Access Compliance Report

Public Rights-of-Way

(Pedestrian Signals)

Intersection ID: N/A	Main Street:	Cross Street: N/A	Location: N/A
ADA ID: B8E66D7D92A3	Signal Type: One Push Button-Non APS	Overall Compliance: No	Severity Score: BTN 1: N/A BTN 2: N/A No BTN: N/A
Codes/Mitigation Info/Possible Solution		Field Measurements/Component Compliance

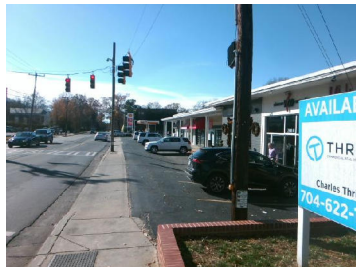
PROW/ADA: TMUTCD 4e.08, R404.3, R404.2

Yes	B 1 Clear Xing Direction?	ClearlyMarked	N/A	B 2 Clear Xing Direction?	N/A
	B 1 Crossing Direction	To SE		B 2 Crossing Direction	N/A
Yes	B 1 DistanceTo XWalk (in)	0.0	N/A	B 2 DistanceTo XWalk (in)	N/A
No	B 1 DistanceTo Curb (in)	123.0	N/A	B 2 DistanceTo Curb (in)	N/A
Yes	B 1 Diameter (in)	2.0	N/A	B 2 Diameter (in)	N/A

Possible Solutions: Replace Signal Push Button With APS Button on New Post. Remove & Relocate Sign.
